EO 55-45-6A

5 Jun 69

LIST OF FIELD MODIFICATIONS
SAFETY HARNESS - GENERAL

Figure 1

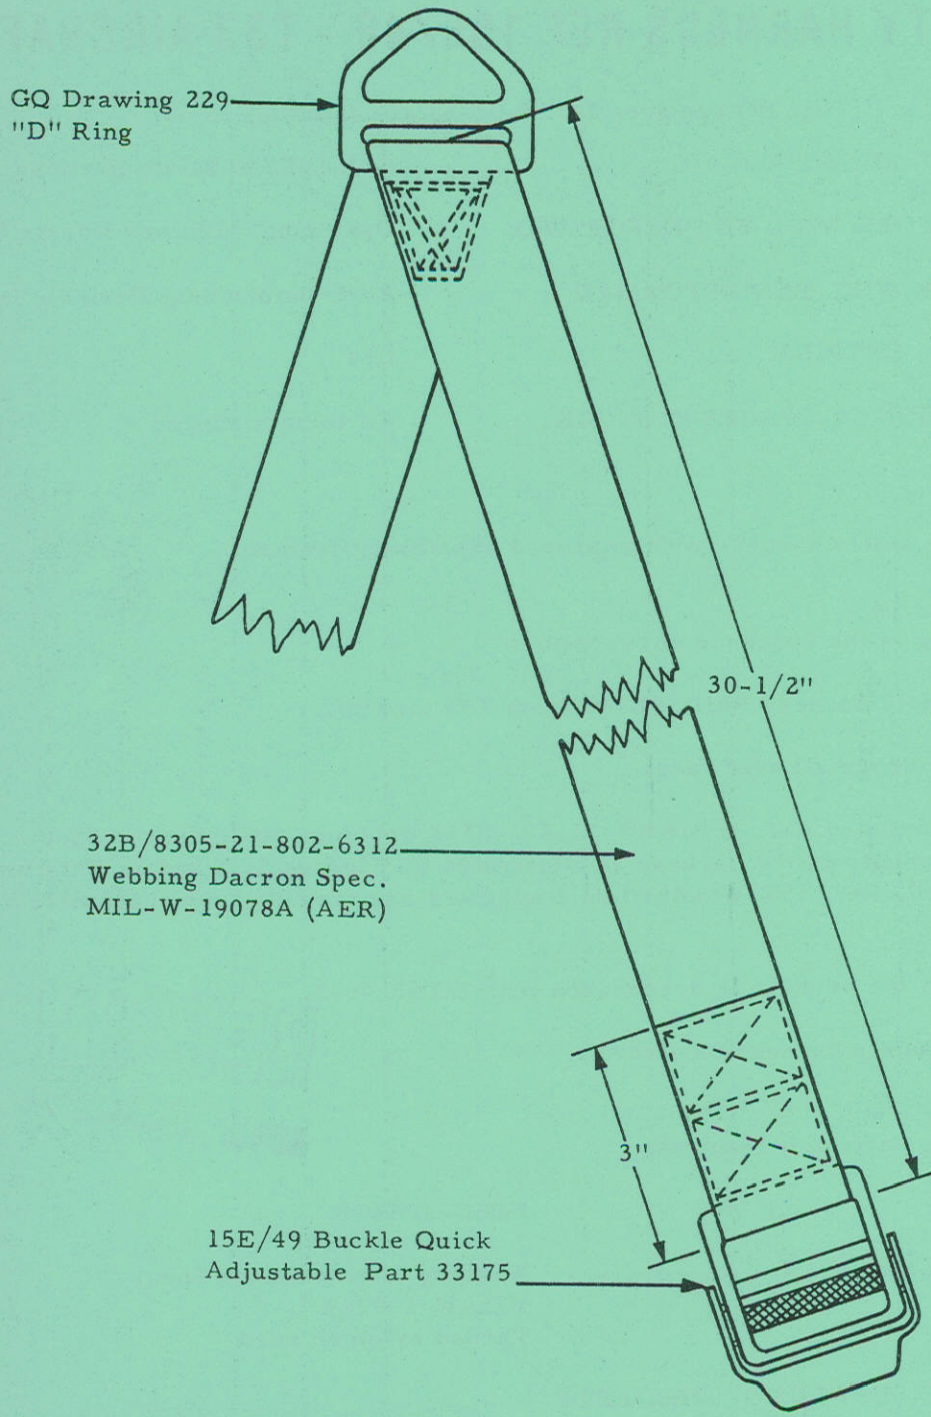
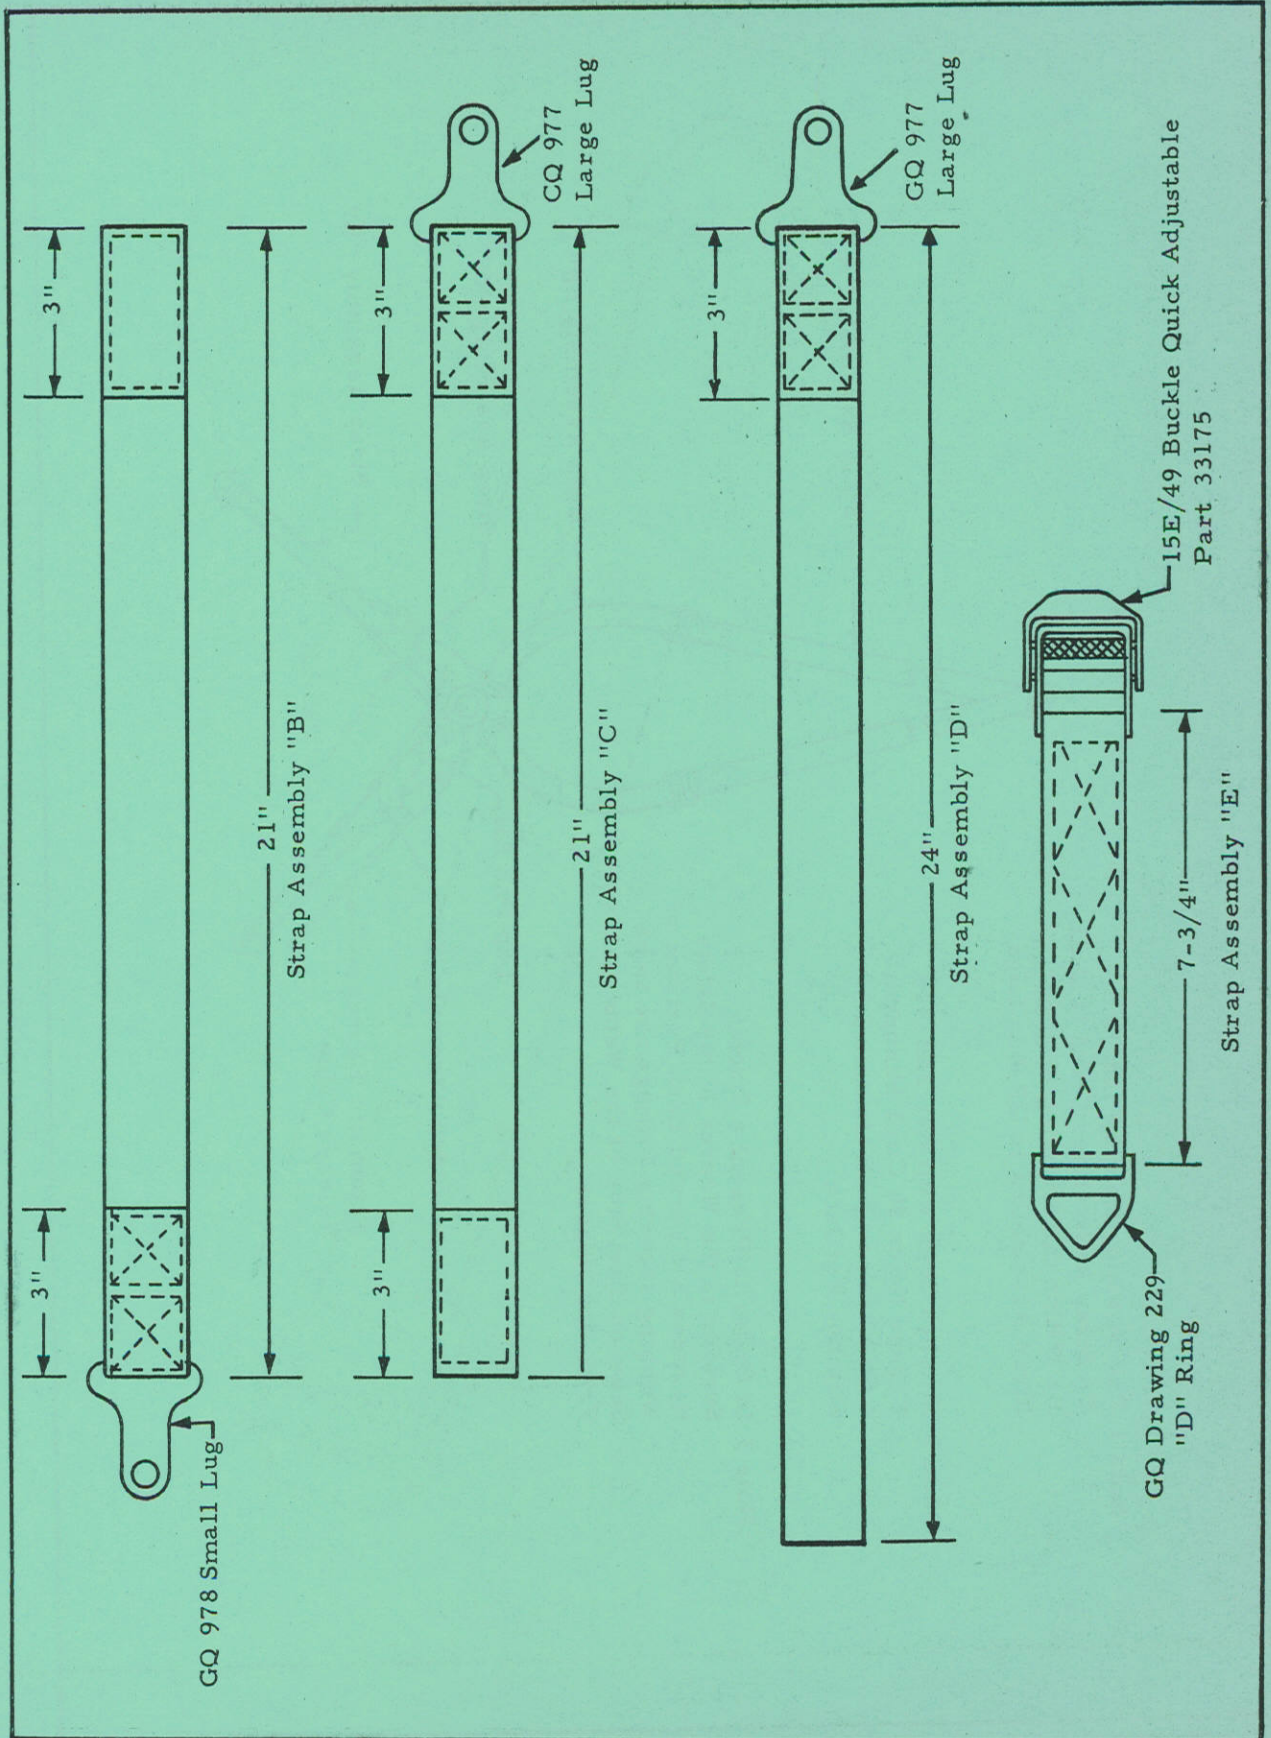
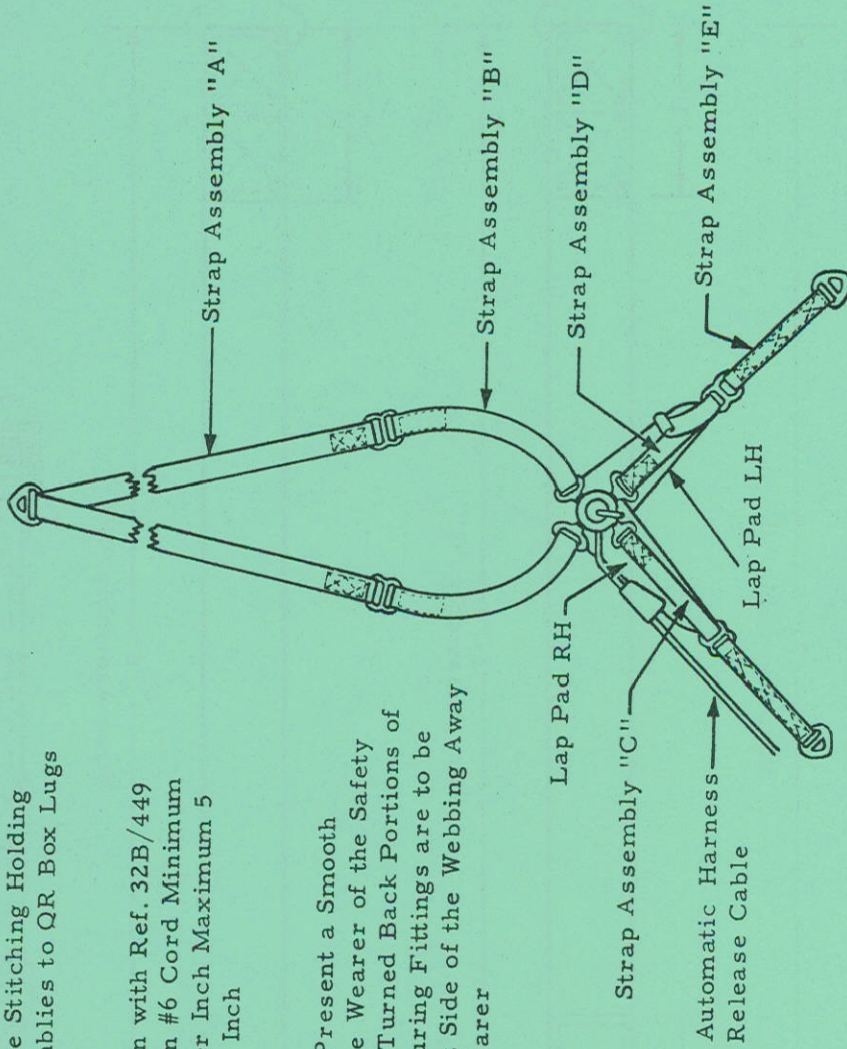
- (a) Remove safety harness Ref. 15E/46 from T33 aircraft.
- (b) Carefully remove all hardware.
- (c) Using new webbing Ref. 32B/8305-21-802-6312 webbing textile dacron Spec MIL-W-19078A reconstruct the harness as illustrated by Figures 1, 2 and 3. Existing hardware to be used. Ref. 15E/49 adjustment adapters are the only type acceptable for this harness.
- (d) Tensile test the harness in accordance with EO 55-45-2.
- (e) Re-install safety harness on aircraft.

Figure 1

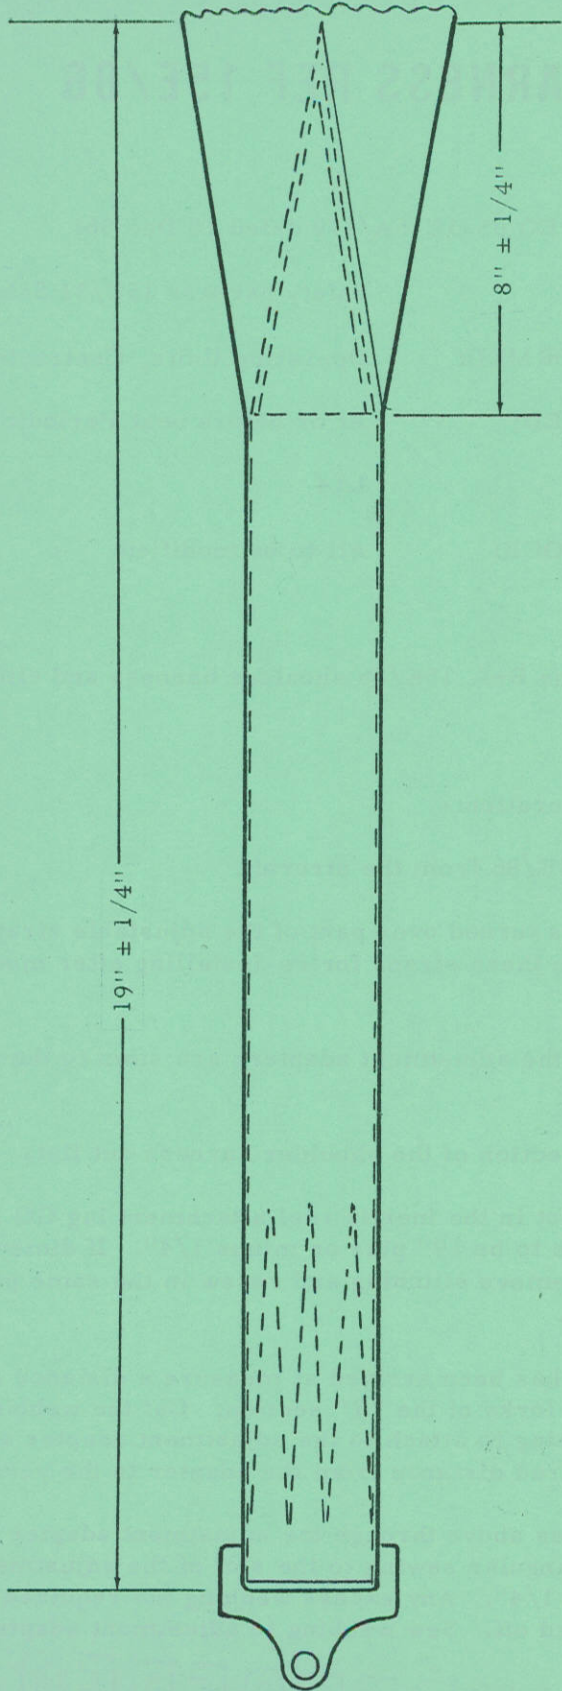
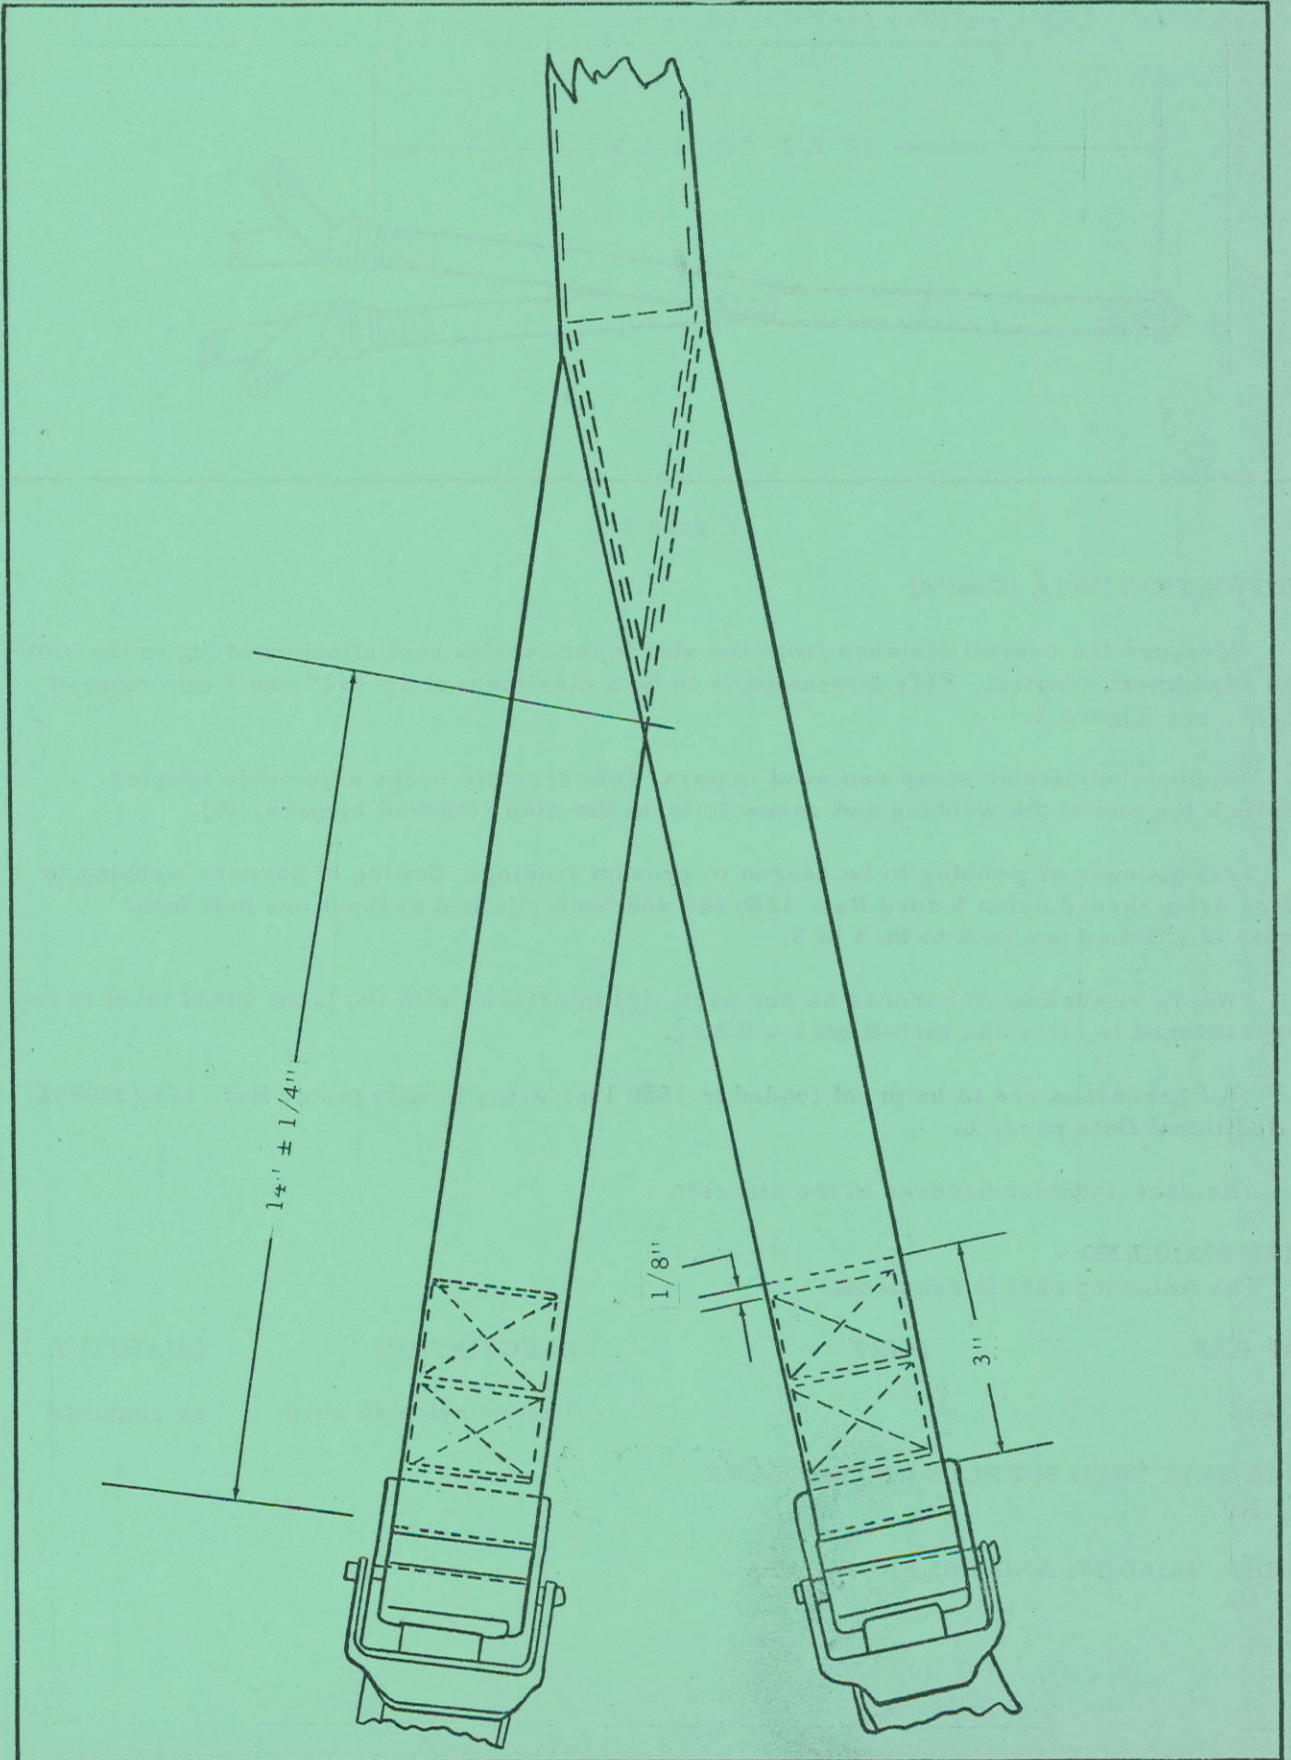
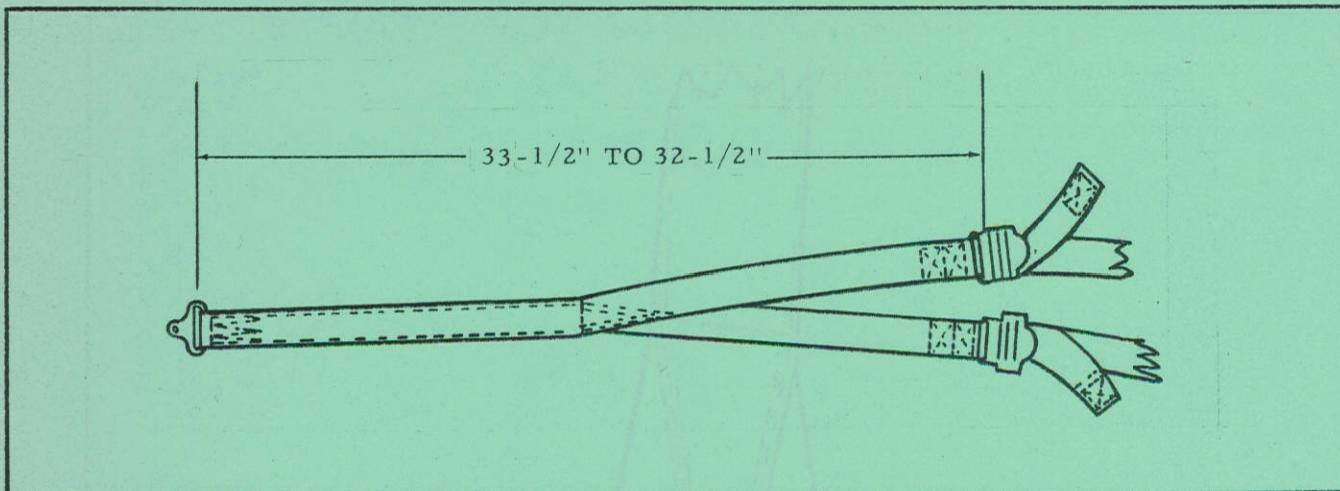
- (e) Length of "Y" section from the slot in the inertia reel attachment lug GQ 1001 to the apex of the triangular stitching or yoke is to be 19" plus or minus 1/4". If dimension is not correct within the tolerances carefully remove stitching and re sew in the same pattern to the dimensions outlined above, see Figure 1.

- (g) Pass the ends of the webbing cut as above through the adjustment adapter slots. Before sewing measure from the apex of the triangular sewing to the slot of the adjustment adapter. This distance must be 14" plus or minus 1/4". Any excess webbing not required to complete a three inch sewing pattern may be trimmed off. Sew webbing to adjustment adapter as per Figure 2.

(h) Measure the overall distance from the slot in the inertia reel attachment lug to the slot in the adjustment adapter. This dimension is to be a maximum of 33-1/2" and a minimum of 32-1/2", see Figure 3.

Figure 1

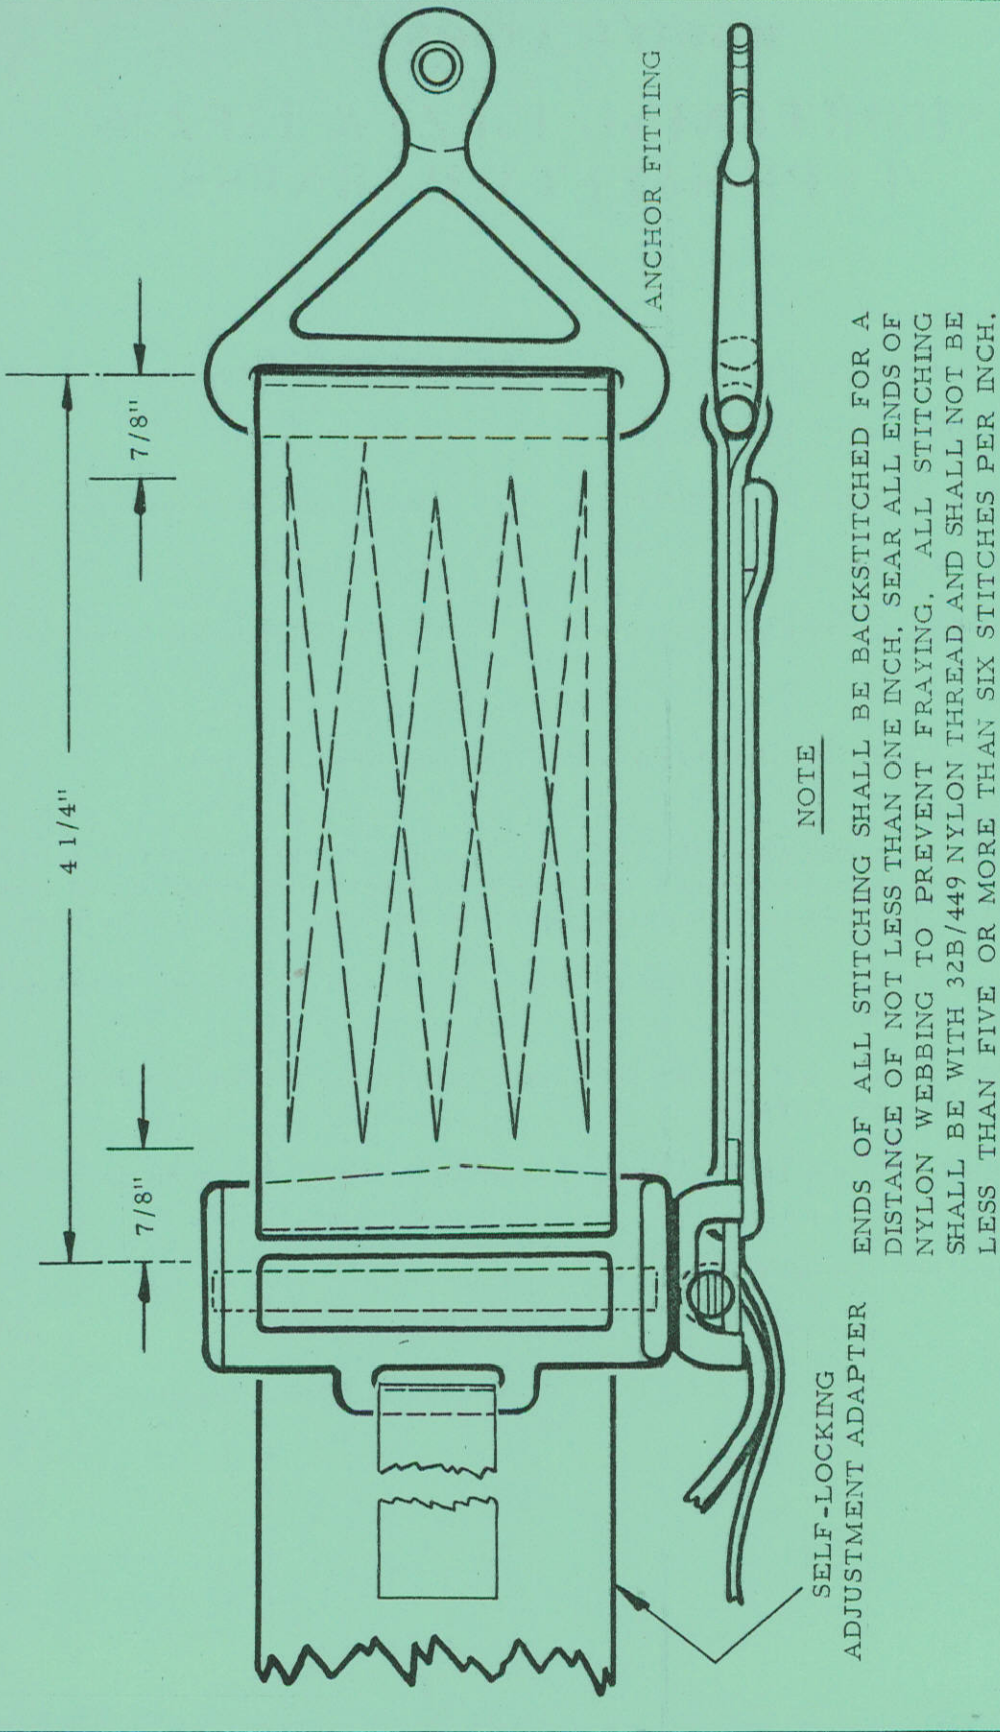
- (a) Carefully cut the stitching where the webbing joins the self-locking adjustment adapter and the anchor fitting, see Figure 1.
- (b) Remove the webbing and shorten sufficiently to decrease the distance between the above fittings to four and one quarter inches.
- (c) Resew webbing as per Figure 1 using thread, nylon, khaki, heavy #6 cord Ref. 32B/449.
